Amendments to the Drawings

REMARKS

Figure 5

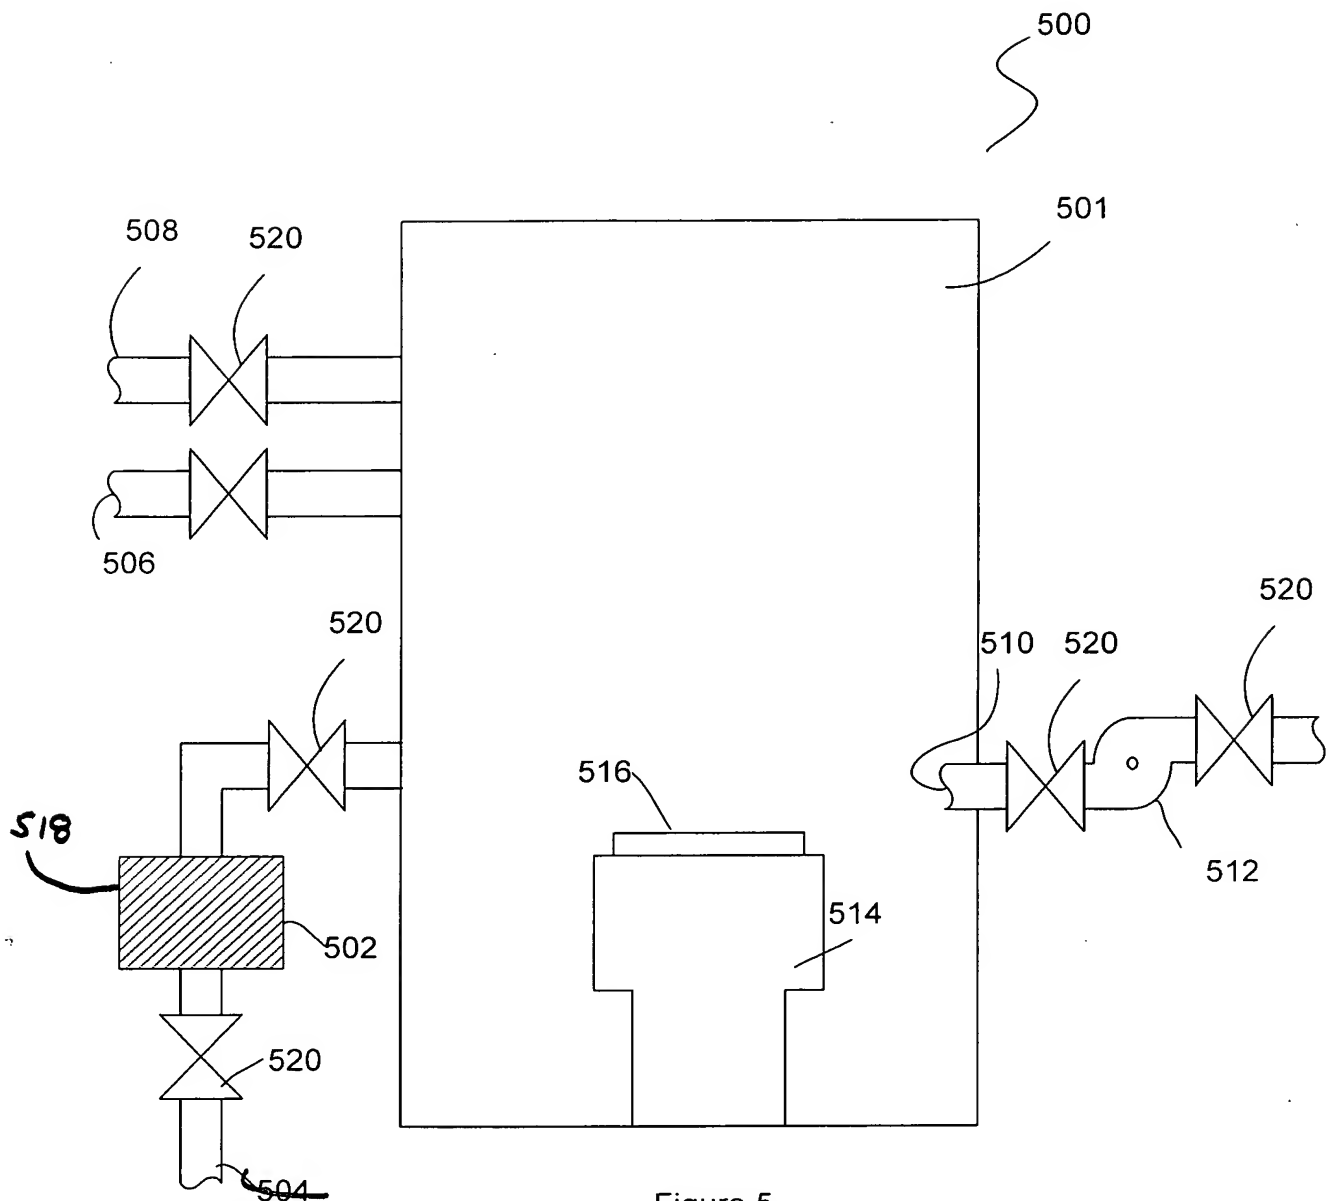
The Examiner has objected to Fig. 5 of the drawings as not including reference number 518 mentioned in the description. Applicants have amended Fig. 5 to include this reference number. The Examiner has also objected to Fig. 5 as including reference number 504 not mentioned in the description. Applicants have amended Fig. 5 to delete this reference number.

The attached sheet of drawings includes an amendment to Fig. 5. This sheet replaces original Fig. 5. Reference 504 has been deleted and previously omitted reference number 518 has been added.

The specification has been amended to correct a typographical error. Fig. 5 of the drawings has been amended to delete reference number 504 and insert previously omitted reference number 518. Support for this amendment may be found in paragraph [0047] of the specification.
